April 3, 2009

Serial No. NA3-09-010R  
Docket No. 52-017  
COL/BCB

**DOMINION VIRGINIA POWER**  
**NORTH ANNA UNIT 3 COMBINED LICENSE APPLICATION**  
**RESPONSE TO REQUEST FOR ADDITIONAL INFORMATION LETTER NO. 033**  
**(PART 10 AND FSAR CHAPTERS 1, 2 AND 12)**

**Figure 1**

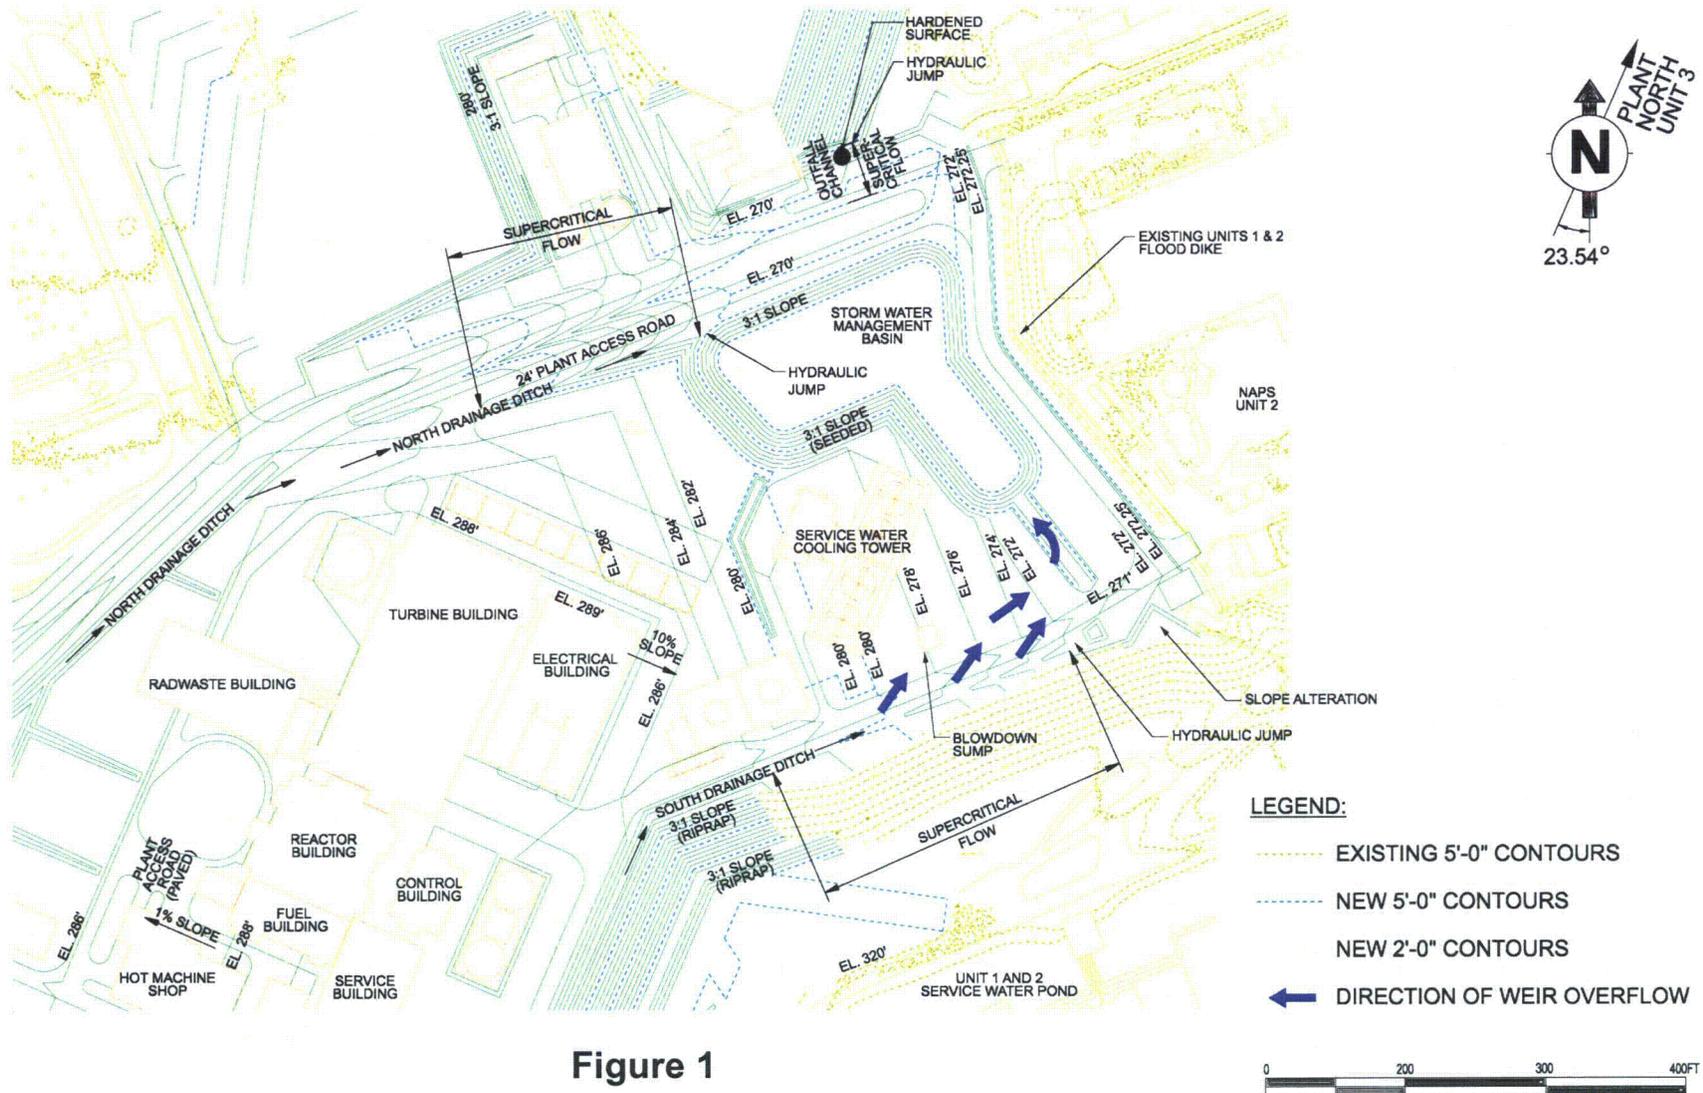
- (c) NRC staff review of the Revision 0 HEC-RAS output noted that supercritical flow occurs in both the north ditch and south ditch, along with velocities that exceed 10 ft/s. Additionally, the overland flow from the lateral weir along the south ditch could reach supercritical velocities during the PMP event. The transition of flow from supercritical to subcritical will produce a hydraulic jump. To clarify the potential impact of these supercritical flows and formation of hydraulic jumps, NRC staff request that the applicant provide a map showing the locations where supercritical flows and hydraulic jumps are likely to occur in the south ditch, north ditch, outfall channel, and associated overland-flow areas. In addition, the map(s) should indicate locations where flood events produce velocities larger than the design velocity for the channel bed material or are capable of eroding overland flow areas (i.e., where damage exceeding normal maintenance would result). At these locations, NRC staff request that the applicant describe how a potential failure of these drainage features could degrade any safety-related SSCs, or structures that satisfy RTNSS criteria.

- (c) Figure 1 (provided for clarification on page 5 of this response) depicts the locations of supercritical flow regimes in the north and south drainage ditches, as well as over the embankment between the storm water management basin and Lake Anna in the outflow channel. The locations of potential hydraulic jumps in the north and south drainage ditches, and in the outfall channel, are also depicted on Figure 1. Although not shown on Figure 1, supercritical flow could also occur in the overland sheet flow from the lateral weir from the south ditch. Because of the low velocities and shallow depth of flow, erosion will not occur during the local PMP event as a result of overflow from the south drainage ditch.

The highest channel velocities occur in the supercritical flow areas for the north and south ditches. The maximum channel velocity is 12.9 fps. Properly sized and placed rip rap channel linings are able to withstand velocities greater than 13 fps. All drainage ditches, overflow areas and embankments at North Anna Unit 3 will be protected with channel lining or surface cover to withstand the predicted flood flow velocities resulting from the local PMP event for the Unit 3 site. Additionally, the lining for the south drainage ditch at the location of the hydraulic jump will be designed to withstand the erosive forces generated by the hydraulic jump during the local PMP event. The lining of the north ditch and storm water management basin side slopes in the vicinity of the north ditch will also be designed to withstand the erosive forces of the hydraulic jump at the inlet to the storm water management basin.

The local PMP analysis considers the outflow structure from the storm water management basin to be completely blocked and inoperable. Thus, all flow out of the basin during the local PMP event is over the embankment between the storm water basin and Lake Anna, which is denoted as the outfall channel in the HEC-RAS model. As shown in Figure 1, the embankment for the outfall channel will be provided with hardened surface protection, such as concrete

lining with proper key-in or other hardened paving, designed to withstand the erosive forces associated with the supercritical flow and the potential occurrence of a hydraulic jump at the embankment section. Thus, no failures of the embankment will occur during the local PMP event.

Figure 1

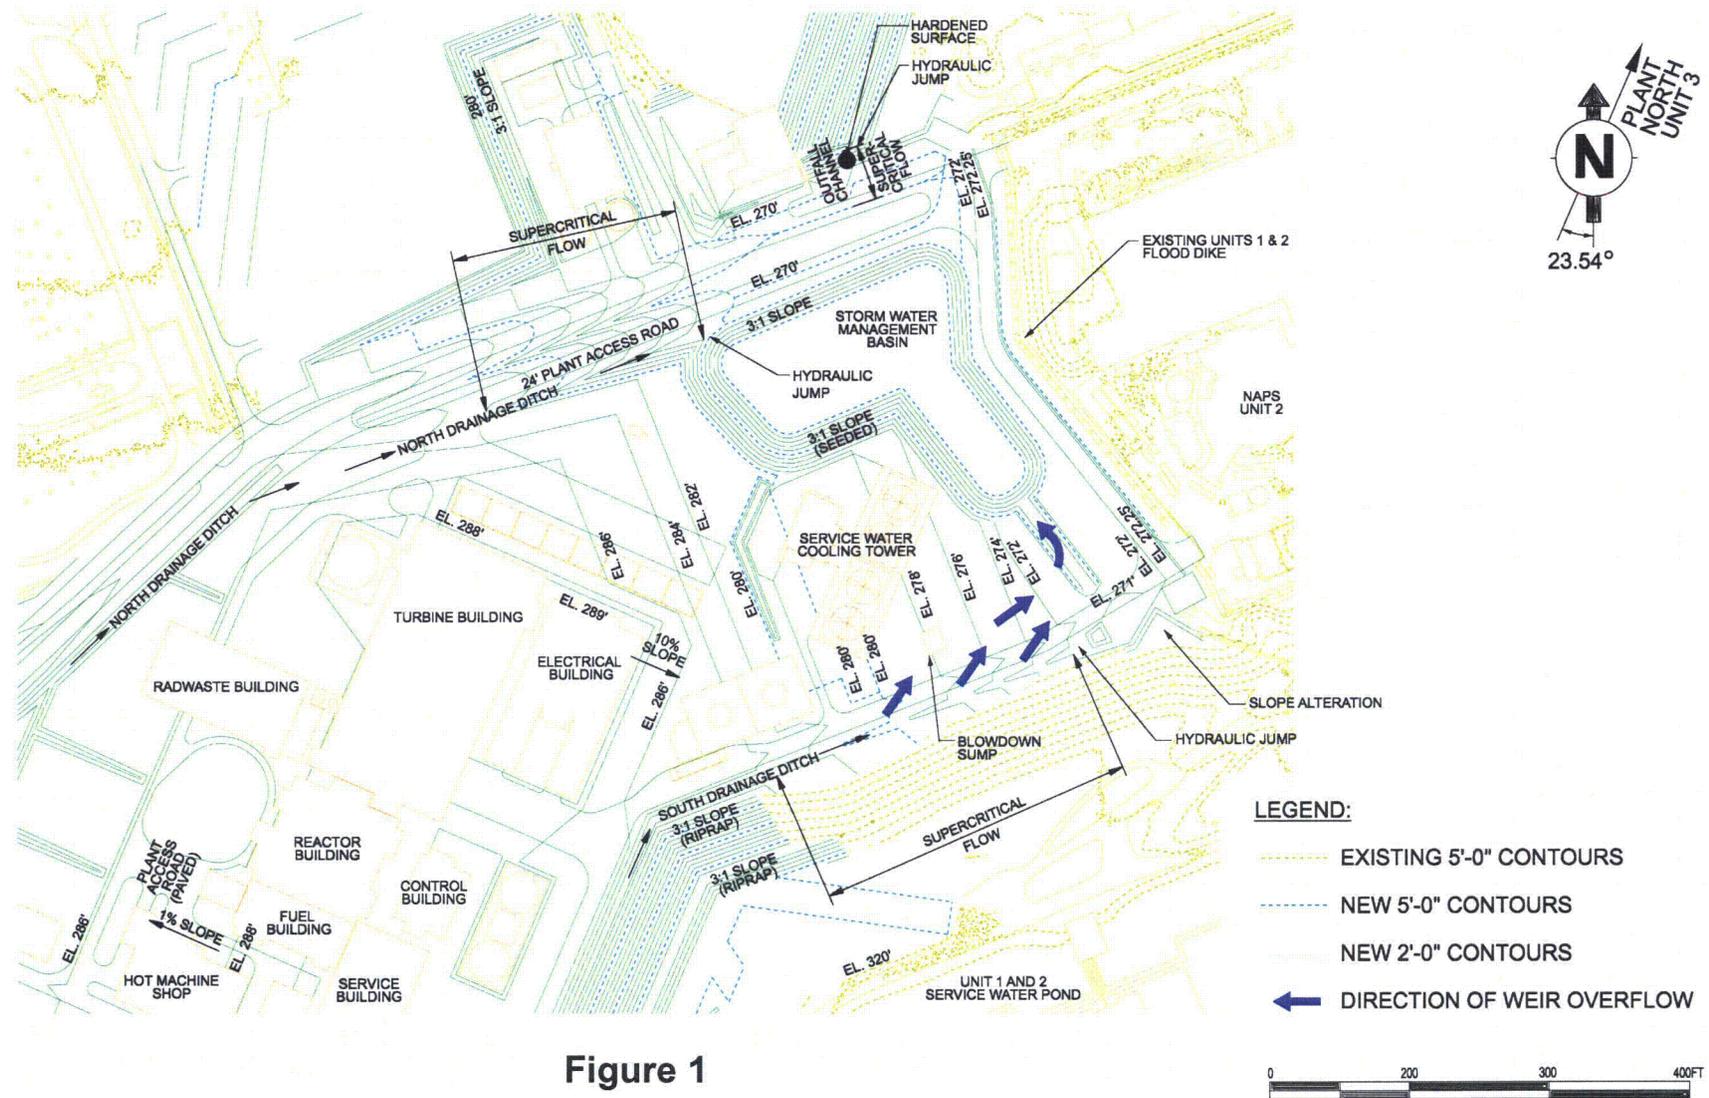
*The COL must contain information to assure that construction of Unit 3 will not impact the existing units (see 10 CFR 52.79(a)(31)). Revision 1 of the application states "at the eastern edge of the Unit 3 site where the plant access road crosses the south drainage ditch, the grade elevation at the high point between the Unit 3 site and the Units 1 and 2 site is at Elevation 82.98 m (272.25 ft) msl. The maximum water level at the inline weir is Elevation 82.94 m (272.1 ft) msl, which is 0.05 m (0.15 ft) below the high point elevation and thus all Unit 3 PMP flows will be confined to the Unit 3 site and runoff generated from Unit 3 will not impact the Units 1 and 2 site." Because the (revision 0) HEC-RAS predicted water velocities in south ditch immediately upstream of the abrupt bend near the plant access road exceed 10 ft/s and because of the relatively small margin, NRC staff request that the applicant describe the design measures to ensure all discharge in the south ditch will complete the 90-degree abrupt bend during the PMP-generated flood event. This description should include how two-dimensional effects, superelevation of flow, and the potential hydraulic jump were factored into the design. In addition, describe fortification measures to prevent failure of the plant access road when the SWM basin is at the PMP-generated maximum elevation.*

Just upstream of where the south drainage ditch crosses the plant access road, the channel slope of the ditch is approximately 3.5%. PMP-generated flood flows in this portion of the ditch are supercritical. Before reaching the culvert, the channel slope of the ditch flattens out to nearly level and a 2.0 foot deep sump is located at the culvert entrance. During normal precipitation events, runoff collected in the south drainage ditch passes under the access road through a culvert. During the local PMP storm event, the HEC-RAS computer model assumes that the culvert is clogged and all flow passes over the plant access road at the culvert crossing. The PMP flood flow is forced above the elevation of the road crossing, resulting in a subcritical flow regime. It is therefore postulated that a hydraulic jump will occur upstream of the sump areas at the culvert crossing, which is also upstream of the abrupt bend in the south ditch.

The channel velocities in the ditch upstream of the hydraulic jump location are greater than 10 fps. However, as indicated in the HEC-RAS model results, the flow velocities for the section of the ditch upstream of the culvert crossing decrease to 2 to 3 fps in the subcritical flow regime downstream of the jump. The turbulence of the hydraulic jump dissipates much of the energy from the high velocities in the upstream portion of the ditch. To direct the flow over the road, the grading of the slope along the south side of the south drainage ditch, downstream of the hydraulic jump, will be altered as shown by the "slope

alteration" in Figure 1 (provided for clarification on page 4 of this response). This slope will be protected with rip rap sufficiently sized to withstand the ditch channel velocities and turbulence associated with the hydraulic jump. The altered grading is located downstream of the hydraulic jump area. This design will confine floodwaters to the Unit 3 site and runoff will not reach the Units 1 and 2 site. The structure shown near the altered slope in Figure 1 is an existing Units 1 and 2 plant building which does not perform a safety-related function and is not credited for directing flow for Unit 3.

The conveyance flow width over the access road was conservatively restricted to 100 feet (60 feet left (west) and 40 feet right (east) of the channel centerline) in the HEC-RAS model. The actual width of water flowing over the road is about 160 feet. By restricting the flow to this width, computed water levels are higher than those that would be computed with a wider section. Even with this channel width restriction, the super-elevation at the outer bend as a result of the flow turning will be small (estimated to be on the order of 0.10 ft based on the water surface width to radius of curvature ratio of no more than one in a subcritical flow regime) due to the much lower velocities near the bend (about 2.5 fps) and will be against the altered slope shown on Figure 1.
